SCOPE OF WORKS PROPOSED IN VARIATION

Project	VICTORIA PARK ZETLAND
Drawing Title	O'DEA AVE KERB ALIGNMENT ALIGNMENT COMPARISON PLAN
Client	LANDCOM
Scales	1:500
Council Project No.	
Architect / Project Manager	
Project Number	06s023
Dwg. No.	SK25
Sheet	of
Revision	A

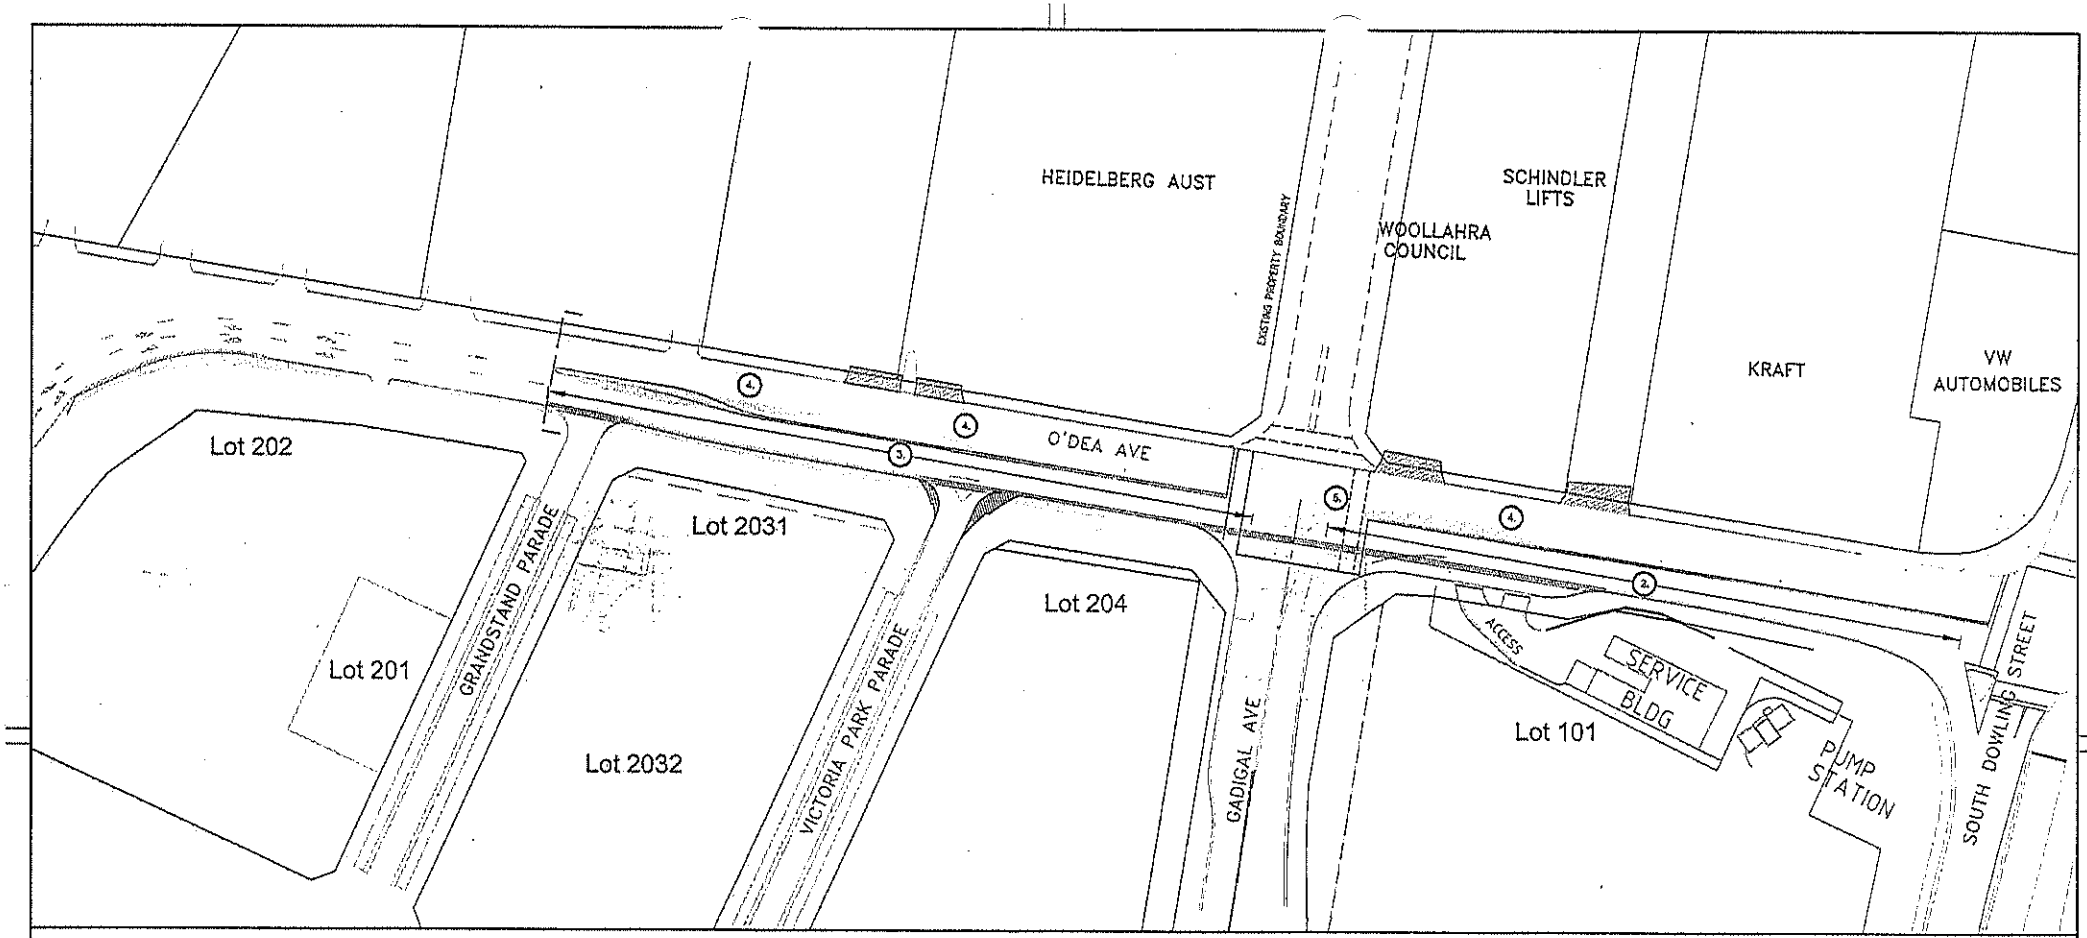
1. O'Dea Ave is to be widened between South Dowling St and Grandstand Pde by re-aligning the southern kerb.
2. Kerb alignment on southern side of O'Dea Ave between South Dowling St and Gadigal Ave remains unchanged from alignment approved in 2001.
3. Proposed kerb re-alignment west of Gadigal Ave to join into existing kerb at Grandstand Pde is proposed to be varied from alignment approved in 2001. This re-alignment accommodates two lanes of traffic in each direction along O'Dea Ave and an additional 90m right turn lane into Gadigal Ave from O'Dea Ave.
4. Revised medians in O'Dea Ave have been replaced by linemarking to maintain existing access to driveways.
5. Provide for additional future crossing at signals.
